January 23, 2009

IRVINGTON WATERFRONT STUDY
Village of Irvington, NY

Prepared by:
BFJ Planning
115 Fifth Avenue
New York, NY 10003
In Association with:
Gregg C. DeAngelis Architects

This draft study was prepared by BFJ Planning at the request of the Village Board of Trustees to help them evaluate a zoning amendment petition and development proposal submitted by Bridge Street Properties, LLC on February 13, 2007 for a 3- acre waterfront parcel located in the Village of Irvington, New York. As of the date of its publication by the Board of Trustees (January 23, 2009), this study does not represent the position of, and has not been endorsed by, the Board of Trustees.

FIGURE 9: BRIDGE STREET PROPERTIES PROPOSAL

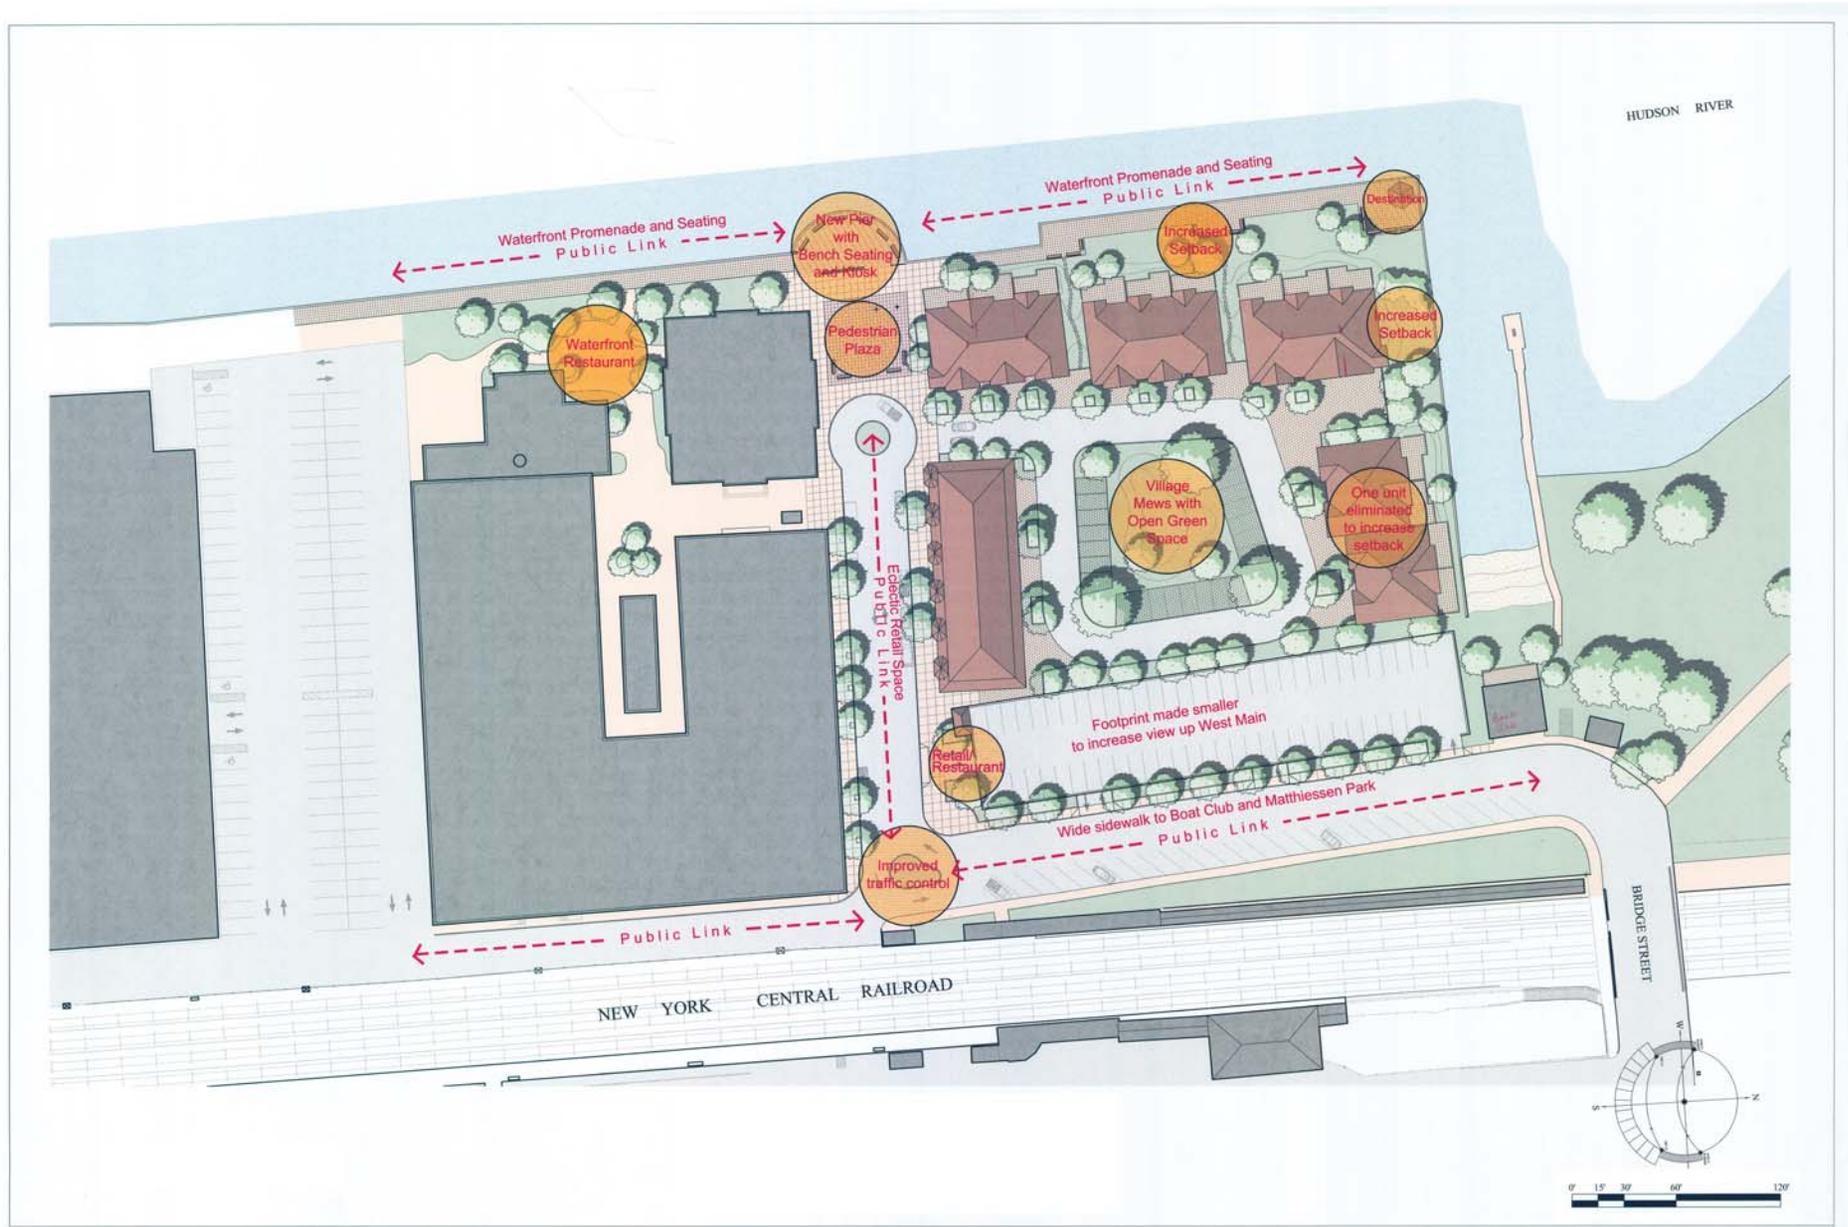
3. **Yard and Setback Requirements:** No front yard is required. We recommend instead that buildings are set back at least 10 feet from Main Street and 5 feet from Bridge Street. The concept plans currently indicate a minimum 12 feet from

Main Street and 5 feet from Bridge Street. We recommend a minimum separation between buildings of 10 feet. The concept plan indicates 5 feet between the parking structure and mixed use building fronting on Main Street. We believe this is too narrow and should be adjusted. Rear yards would be 10 feet. Setbacks from the Hudson River are 25 feet with a 10 foot wide allowance for a private terrace. Parking structures must be set back 75 feet from the Hudson River.

FIGURE 23: BFJ RECOMMENDATIONS

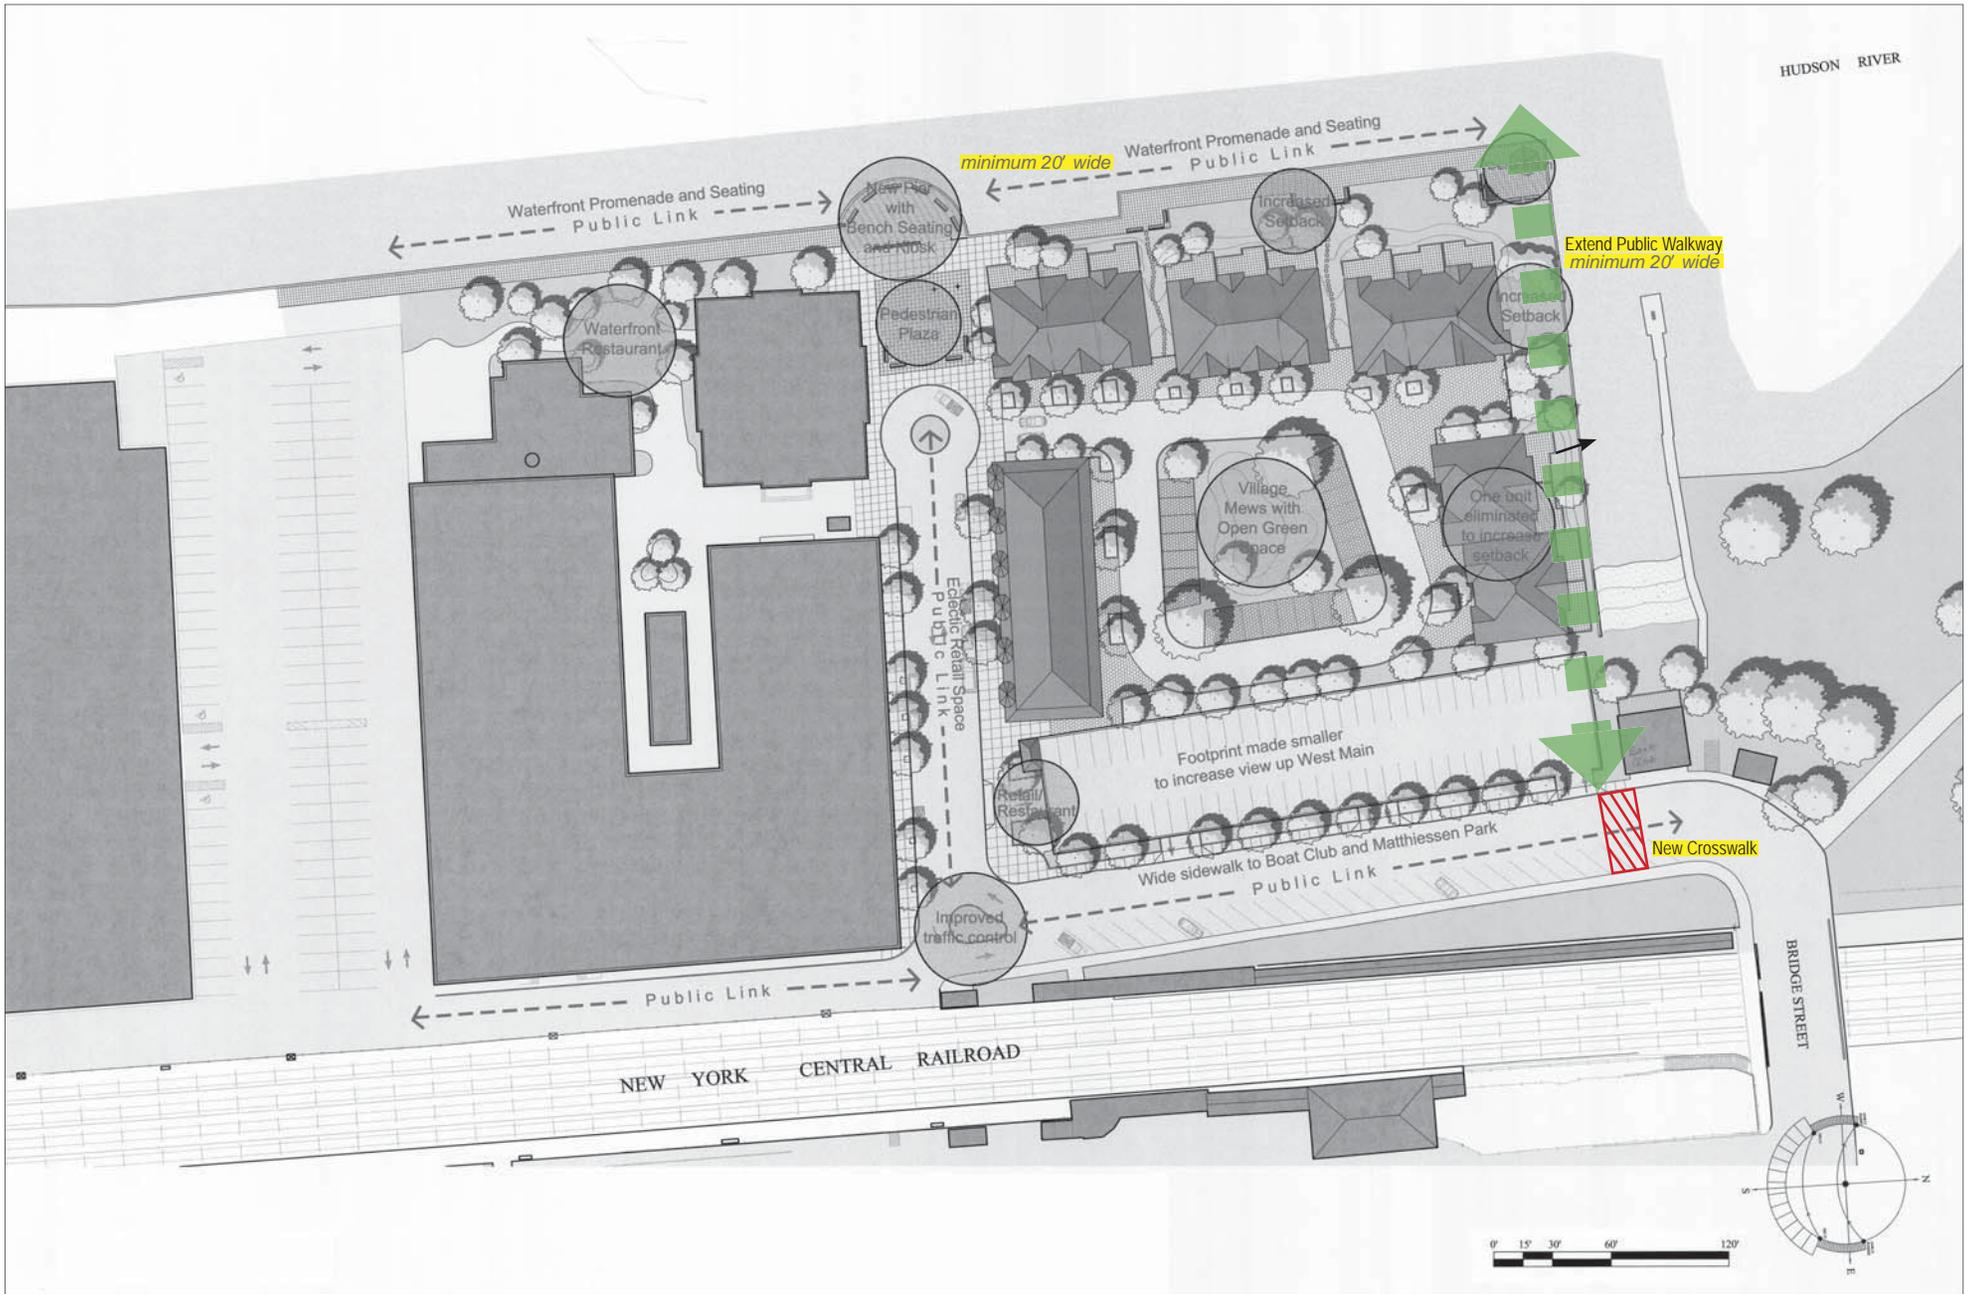
Public walkway: As currently proposed, the waterfront promenade extends the full length of the property terminating at the northwest corner. We understand that access to Matthiessen Park is restricted to the public; however we suggest that the promenade might be extended on the north edge of the property to connect to Bridge Street via a walkway in between the boat club and the parking garage. This may require the parking garage to be reconfigured to accommodate a walkway and would result in the elimination of approximately 8 parking spaces. Please see Figure 22. We also recommend that based on our experiences with comparable waterfront developments in similar communities, that the width of the public esplanade be a minimum of 15 feet. This may require a reconfiguration of the site plan.

New crosswalk: To provide a connection for the walkway suggested above and described on the attached plan, we recommend a crosswalk should be added at Bridge Street (see attached sketch). This will require eliminating some of the diagonal parking spaces.

New Sidewalk Connecting Bridge Street to Scenic Hudson Park: Another recommendation that is also contained in the Comprehensive Plan is to provide for safe pedestrian passage on Bridge Street south to Scenic Hudson Park. This might include a narrow sidewalk or paving leading from the train station underpass and crossing south towards Scenic Hudson Park.

Parking Deck: We recommend that the parking spaces within the deck should be at least 8 ½ feet wide and the deck itself can be up to 65 feet wide. 65 feet allows for two rows of parking (at 18 feet deep each) separated by a 22 foot wide drive aisle with an additional 5 feet to allow for wall thickness and some flexibility in the design of the exterior. As proposed the garage height appears to be 28 feet. This height results in unfeasibly low floor to ceiling heights. A more realistic height is 32 feet.
